RC1: ['Comment on hess-2024-7'](#), Anonymous Referee #1, 02 Apr 2024

**Review for “System dynamics perspective: lack of long-term endogenous feedback accounts for failure of bucket models to replicate slow hydrological behaviors”**

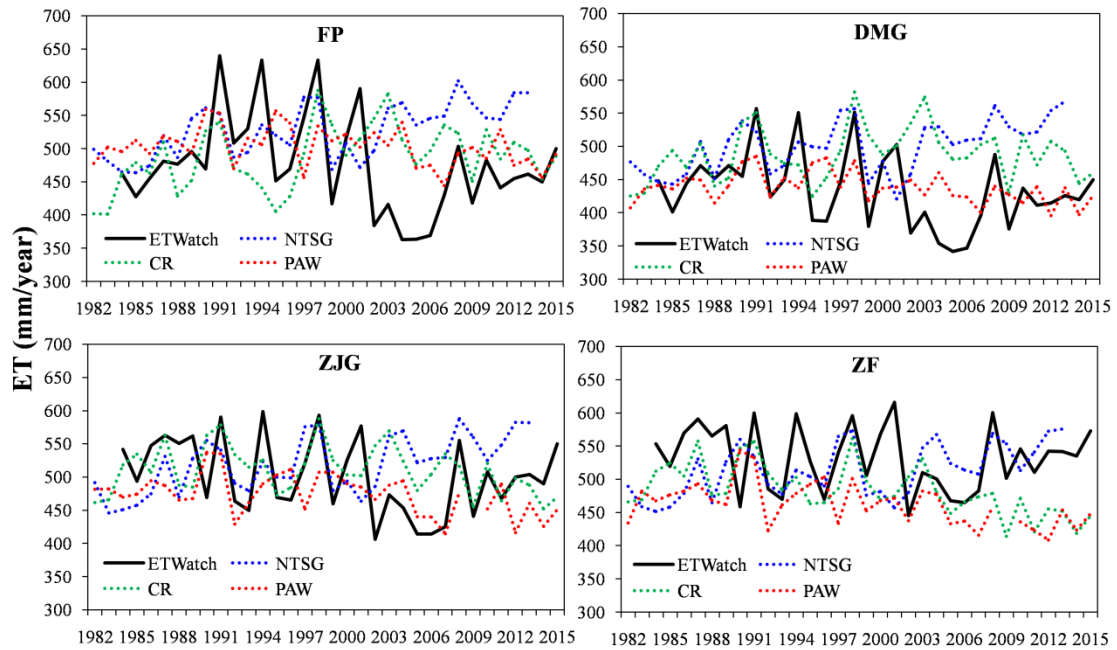
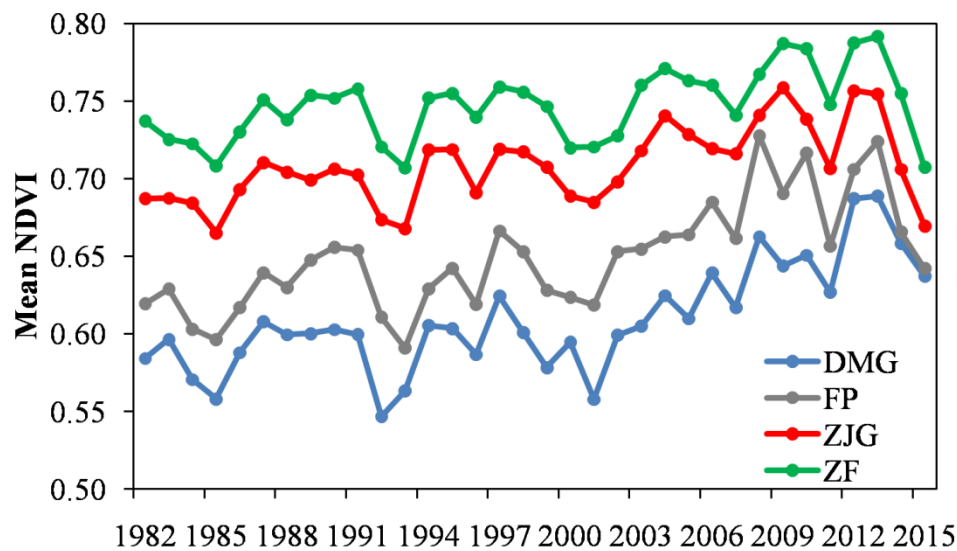
The products of actual evapotranspiration contain much uncertainties. The authors should be very careful with the products and validation of the accuracy in the region is recommended.

Reply: Thank you for the comment. Due to the absence of ET observations during study period, we resorted to three alternative ET products - NTSG (Numerical Terra-dynamic Simulation Group), CR (Complementary-Relationship-based modeling), and PEW (Proportionality hypothesis-based surface Energy-Water balance model) - for cross-validation with ETWatch (as depicted in the figure below). These products employ distinct algorithms, namely Penman-Monteith for NTSG (Zhang et al., 2009a,b), Complementary-relationship for CR (Ma et al., 2019a,b), and Priestley-Taylor for PEW (Fu et al., 2022a,b). Despite their algorithmic difference, they exhibit common characteristics in long-term data.

Firstly, all the products successfully capture the annual ET fluctuations. Secondly, in terms of long-term trends, all products indicate a decline in ET in the end of 1990s and the beginning of 2000s. While the ET of NTSG and ETWatch shows an upward trend thereafter, however, the ET of CR and PEW continues to decrease in the study period. Thirdly, the magnitude of ET fluctuations is comparable among all the four products, being more pronounced during the wet phase and less so during the dry phase.

Given these observations, we conclude that the ETWatch product demonstrates reliable values and the most distinguishable fluctuations among the four ET products, thus standing out as a reliable choice for ET estimation.

The above paragraph has been added in Method section.

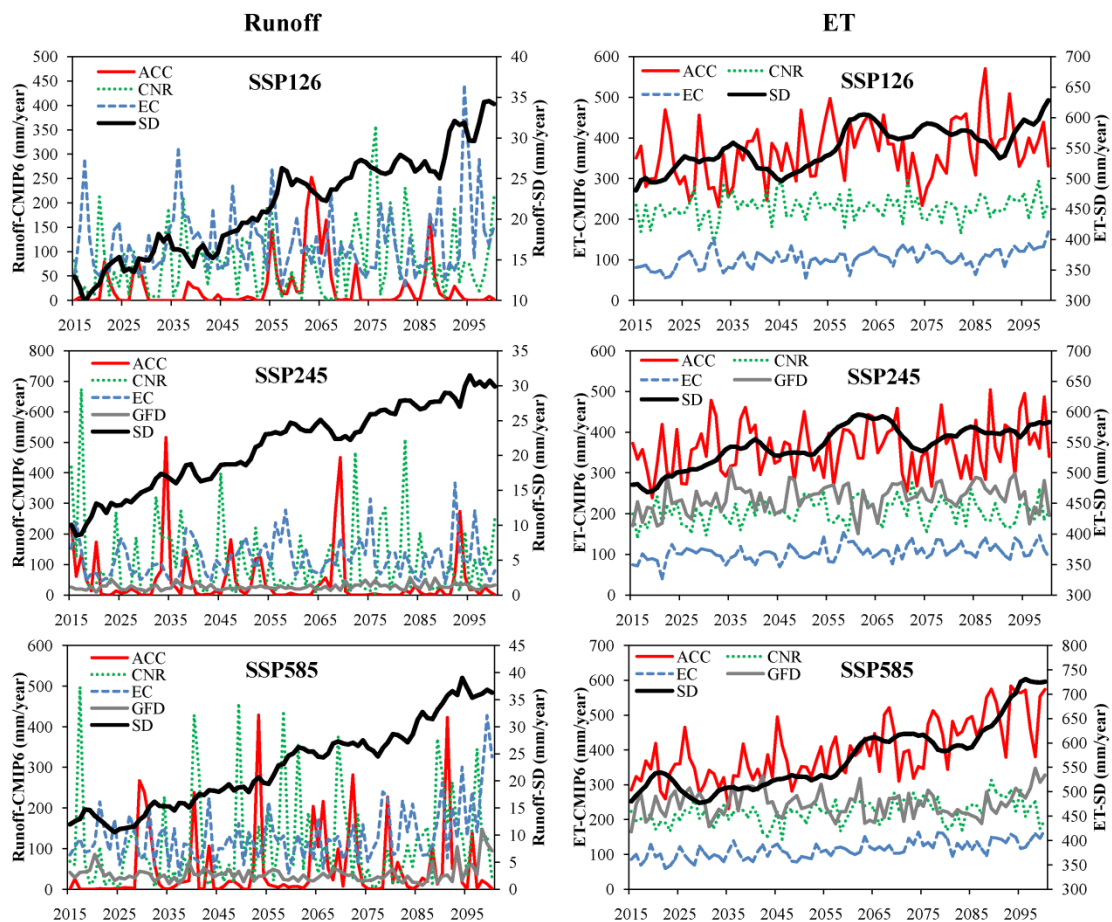
Future dynamics of hydrological systems under three climatic scenarios are shown in Fig 7. But could not catch what the key points the author wanted to address.

Reply: Thank you for the comment. The figure has been updated to a new version that contrasts our results with CMIP6 results (as illustrated below). It encompasses monthly total runoff ("mrrro" in CMIP6) and evapotranspiration ("evspsblsoil" and "evspsblveg" in CMIP6), stemming from three scenarios (SSP126, SSP245, and SSP585) within four Global Climate Models (ACCESS-CM2, CNRM-ESM2, EC-Earth3, and GFDL-CM4). These data were retrieved from the CMIP6 (the phase 6 of the Coupled Model Intercomparison Project) website (<https://esgf-node.llnl.gov/search/cmip6/>), covering the time span from 2015 to 2100. Notably, the GFDL-CM4 model lacks the SSP126 experiment, and the ACCESS-CM2 model lacks the "evspsblveg" variable.

The spatial resolution varies, with 250 km for ACCESS-CM2 and CNRM-ESM2 models, and 100 km for EC-Earth2 and GFDL-CM4 models. The values pertaining to the study area were extracted from specific grid cells. For ACCESS-CM2 (CNRM-ESM2), the grid value at the 62nd (83rd) row and 104th (93rd) column, corresponding to longitudes of 115.3125° (115.3125°) and latitudes of 39.375° (39.9218°), were used. Similarly, for EC-Earth3 (GFDL-CM4), the grid values at the 164th (92nd) and 165th (93rd) rows, and the 185th (130th) column, corresponding to longitudes of 114.6094° (114.375°) and 115.3125° (115.625°), and latitudes of 39.649° (39.5°), were utilized.

The unit of  $\text{kg m}^{-2} \text{s}^{-1}$  was converted to  $\text{mm month}^{-1}$  by multiplying it with 86400 seconds and 30 day. Subsequently, annual values were calculated by summing the monthly values. The average precipitation from different SSP scenarios was then employed to drive system dynamics (SD) model, generating runoff and evapotranspiration estimates.

In term of evapotranspiration (ET), SD model aptly captures its primary behavioral patterns: a decline in the 2040s and 2070s, followed by an increase in the 2060s and 2090s. Notably, the R-squared value between SD model and GCMs for ET is relatively higher for the SSP585 experiment, specifically 0.48 for ACCESS-CM2, 0.15 for CNRM-ESM2, 0.41 for EC-Earth2, and 0.04 for GFDL-CM4. However, for other two experiments, the R-squared values are relatively poor.

Regarding runoff, the SD simulations indicate an increasing trend, whereas the GCMs do not exhibit any discernible trend. The R-squared values between SD and GCMs for runoff are poor across all experiments. These findings further emphasize that process-based models, while adept at capturing short-term fluctuations, may be inadequate in simulating long-term hydrological behaviors.

### MK trend analysis for precipitation

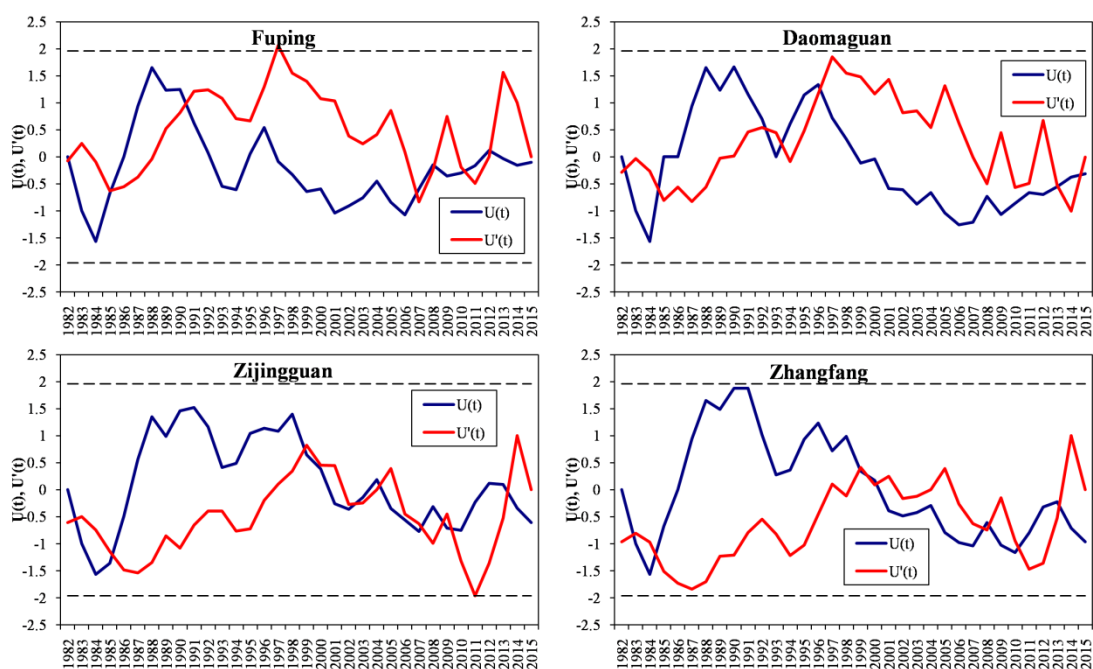
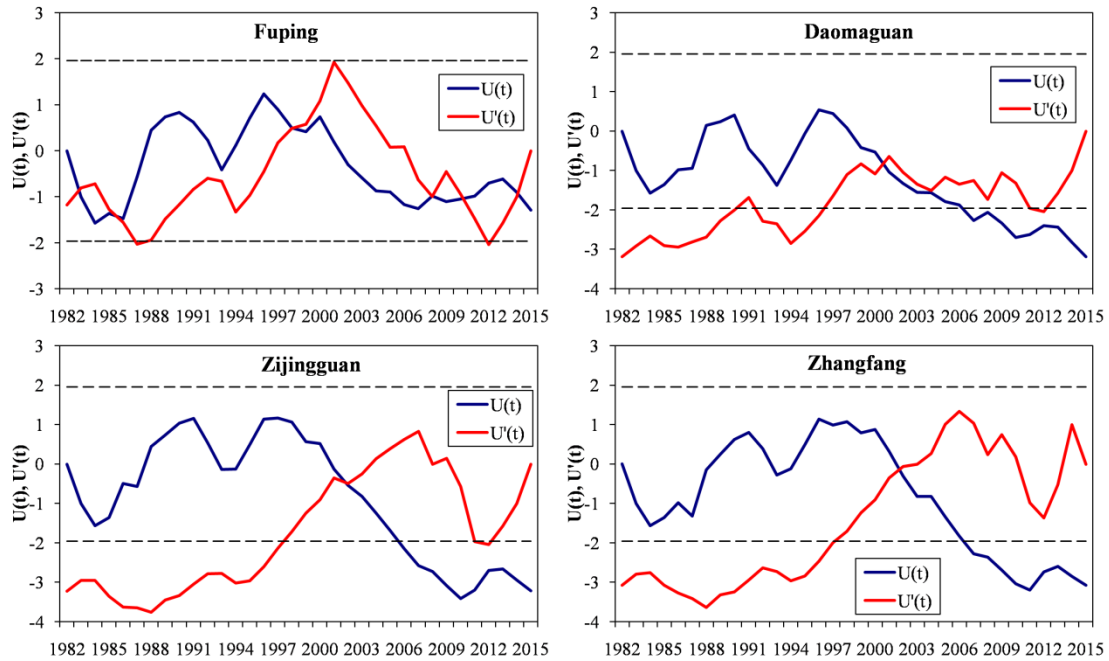
Lines 210-214. The brief description of hydrological characteristics of the wet and dry phase is suggested. Why the wet-dry phase be determined by wavelet coefficient instead of annual precipitation or aridity index?

Reply: Thank you for the comment. To distinguish between wet and dry phase, a comprehensive analysis was undertaken, encompassing wavelet analysis, trend analysis of precipitation and runoff (as figures below), and a literature review about

climate and runoff patterns. Results revealed that precipitation did not exhibit a significant trend, whereas runoff showed a significant decreasing trend during the study period, with a tipping point around 2000, aligning with previous studies. The literature review highlighted that the PDO index, which is closely associated with summer rainfall in East China, underwent a shift from positive to negative phase at the end of 1990s. Furthermore, wavelet analysis indicated a reduction in the magnitude of fluctuations in wavelet coefficients for all 4 variables after 2000. Based on this collective evidence, it was determined that the hydrological system has transitioned from wet phase to dry phase in 2000.

This description will be added in Method section and figures will be added in supplementary document.

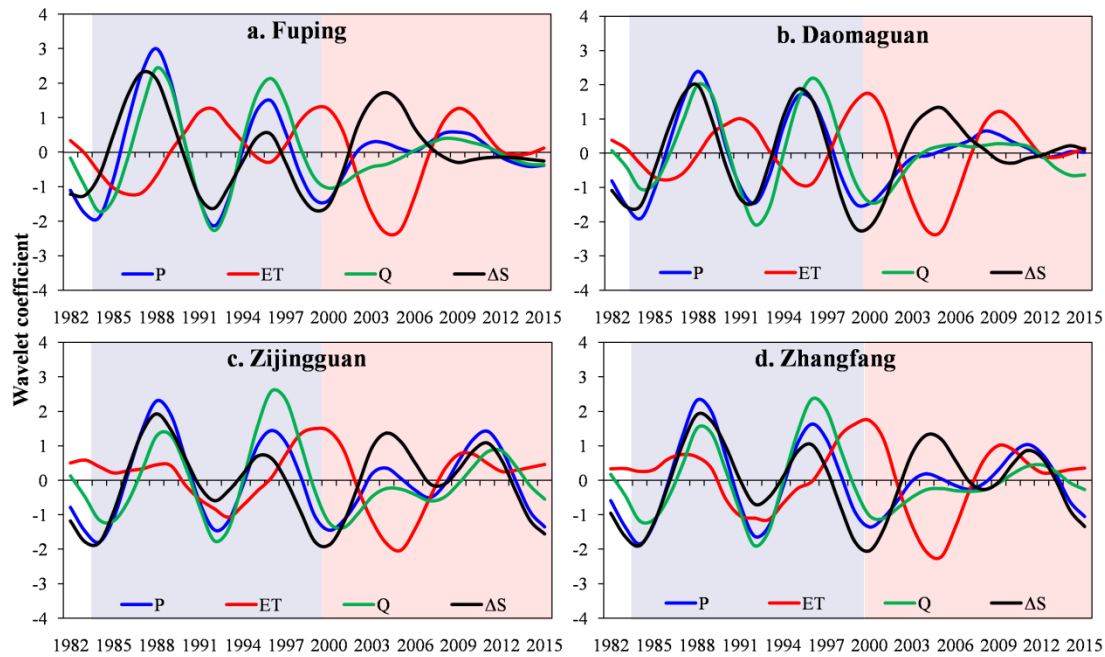
Figure 2. The choice of colour is confusing - Greens and blues are typically reserved for fluxes like precip and streamflow, while reds and yellows for ET. So, swap colour of P and ET.

Reply: Thank you for the comment. The figure has been revised as this suggestion as below.
